TO: All Bidders under **ITB No. 21-101358, Renovation and Development of the 178 Sams Street Facility**

ADDENDUM NO. # 2

Invitation To Bid (ITB) No.: 21-101358, Renovation and Development of the 178 Sams Street Facility is hereby amended as follows:

A10.02

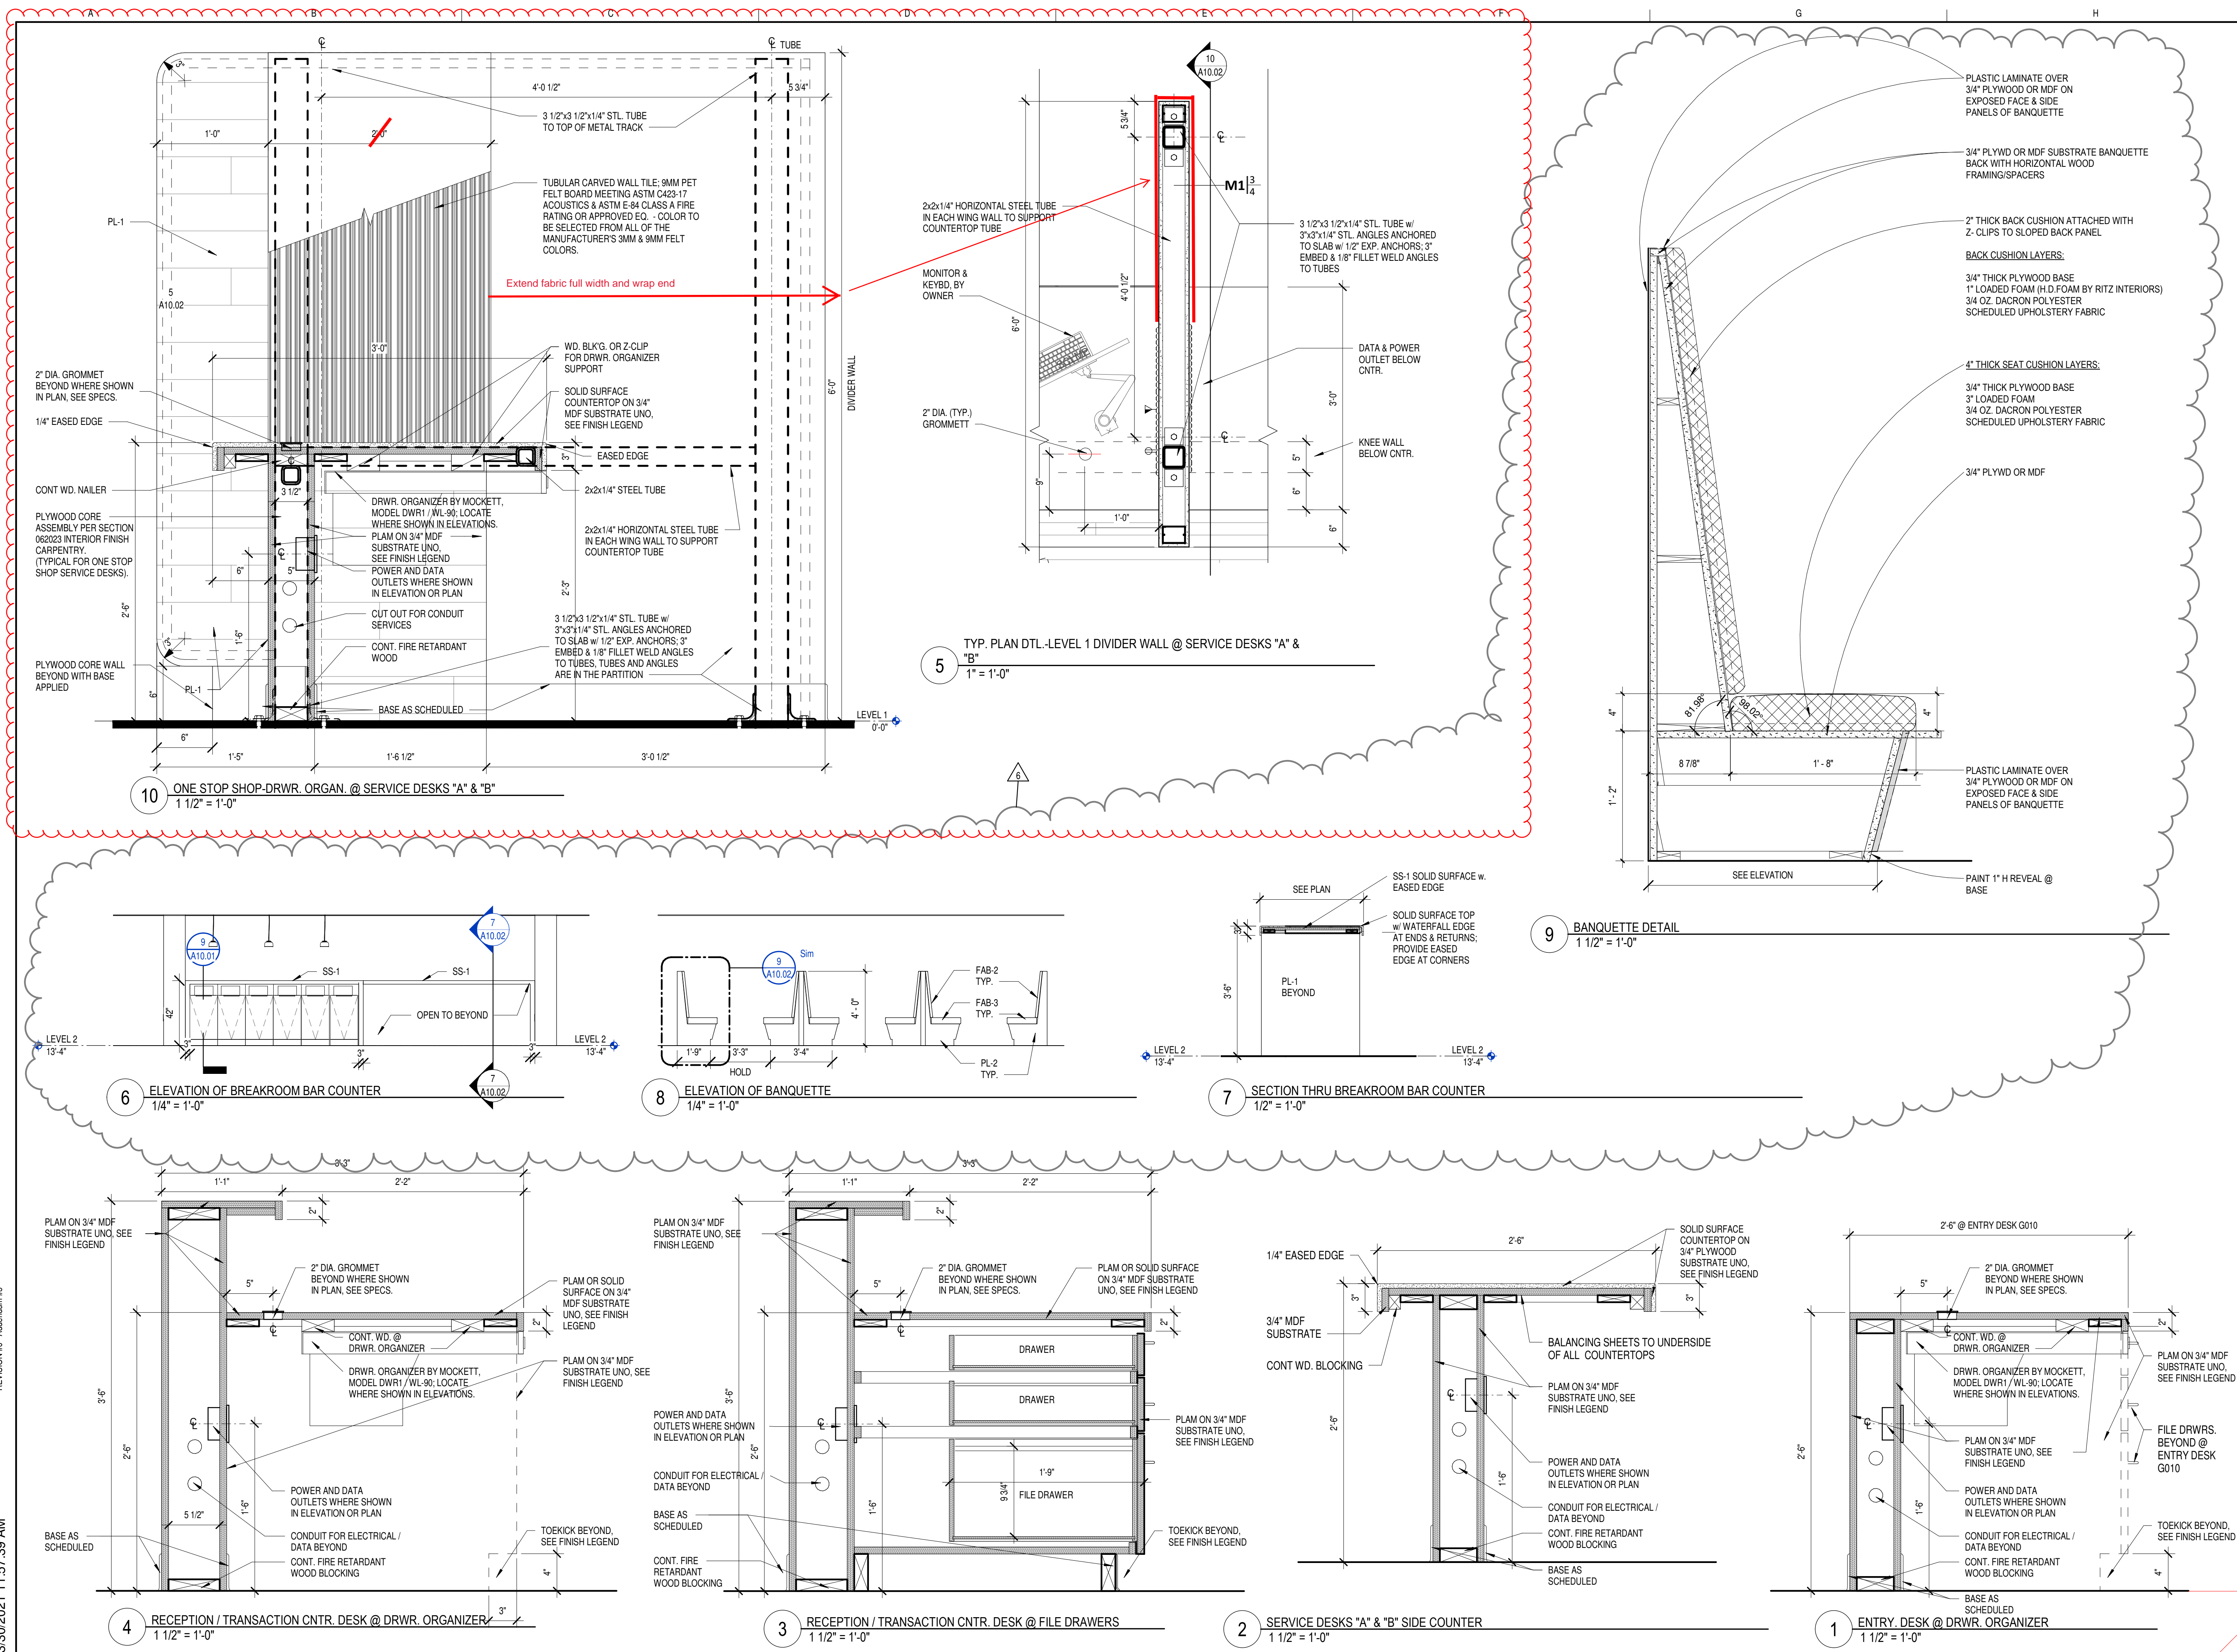
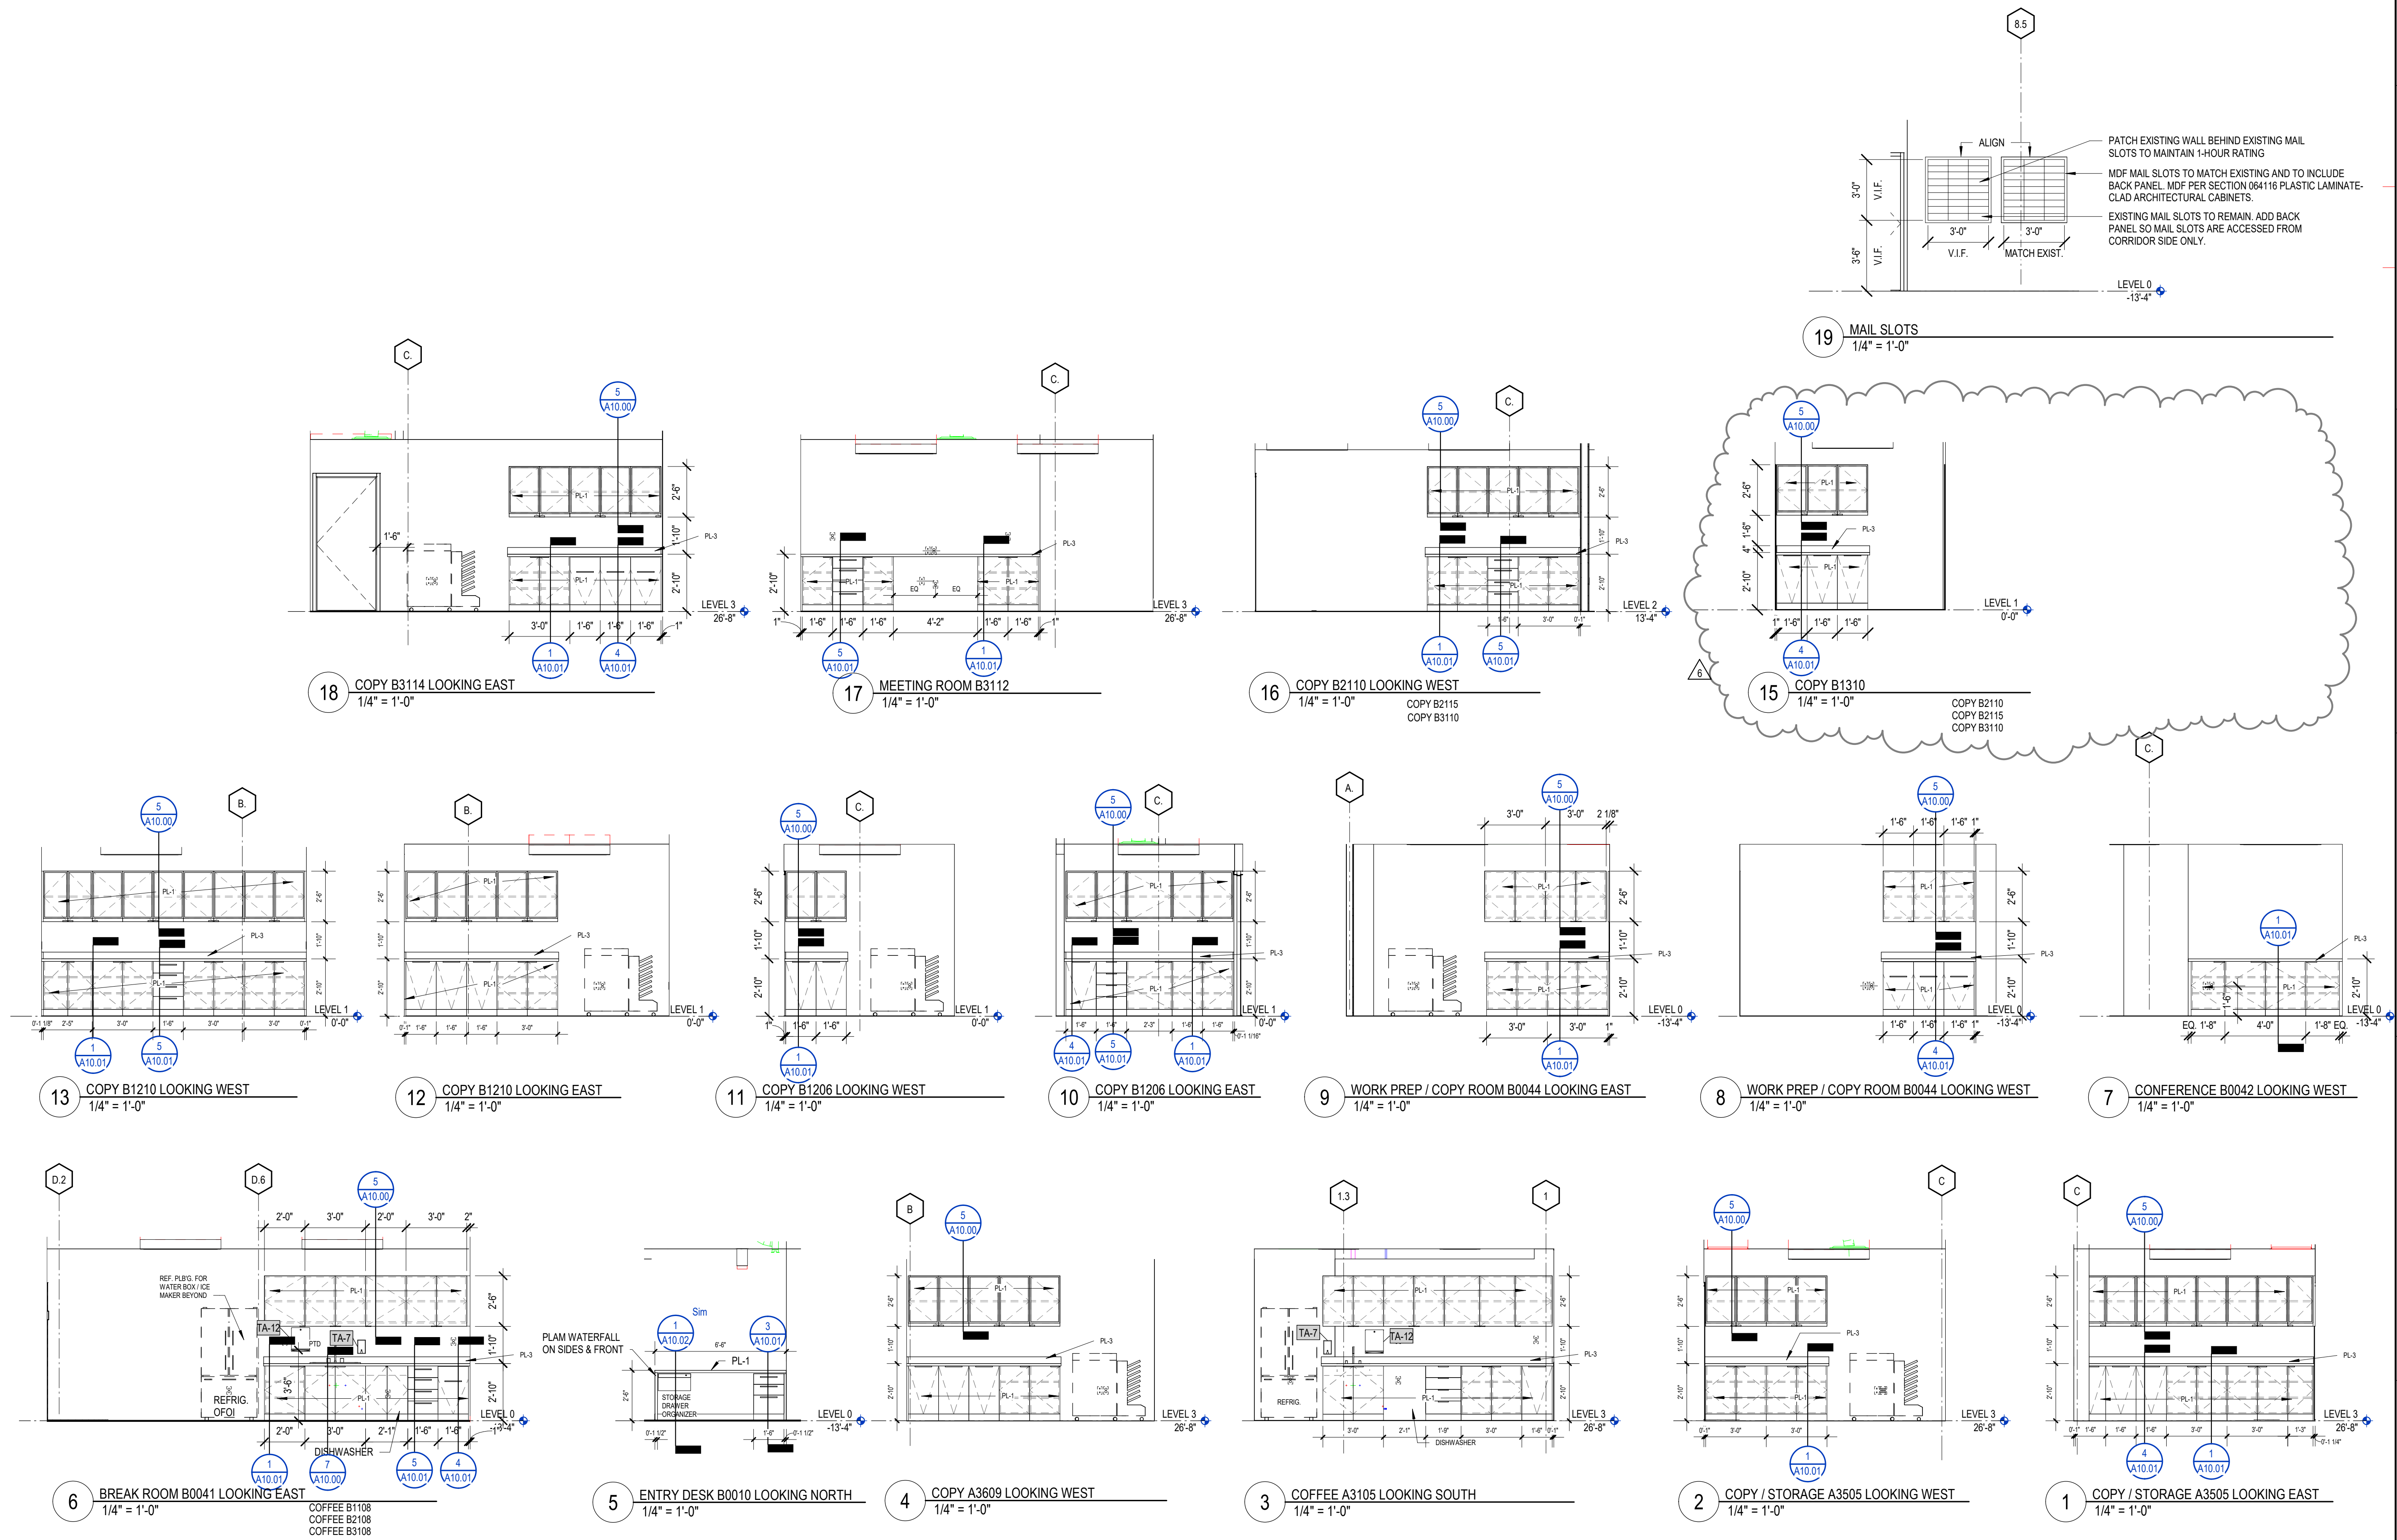
VVV. **Question:** A10.02 and A10.03, 5/A10.03 and 7/A10.03 shows the Turf Tubular Felt running the entire back of house length of the divider panel. 11/A10.03 shows the felt running partially down the entire boh length of the divider panel. 10/A10.02 shows the felt running 2' down the panel. 5/A10.02 shows the felt running only partially down the panel. Please clarify the extent of the felt on the divider panels.

WWW. **Question:** A9.12, Please provide further information on counter in A2107.

XXX. **Question:** A9.12, Is banquette seating in A2107 owner provided furniture?,

Answer: Details 5 & 7 / A10.03: Fabric covers the entire width of panel including wrapping end of panel, except where PL-1 is indicated at 11'-1/2" width.

Detail 11/A10.03: Felt is to cover panel as indicated. similar to 5 & 7 / A10.03

Detail 10/A10.02 Felt has been shown with a vertical cut line to allow the tube steel within the panel to be seen. Width of fabric panel is shown incorrectly. Fabric is to extend the full width of the panel including wrapping end of panel except for the 11'1/2" width of PL-1.

Detail: 5/A10.02 Width of fabric panel is shown incorrectly. Fabric is to extend the full width of the panel including wrapping end of panel except for the 11'1/2" width of PL-1, (marked up on attached sheet)

Answer: Refer to elevation 6 and 7 on sheet A10.02 released in this addendum.

Answer: Banquette seating in Breakroom A2107 is to be furnished under this bid contract. See elevation on 8/A10.02 and section on A/A10.02 released in this addendum.
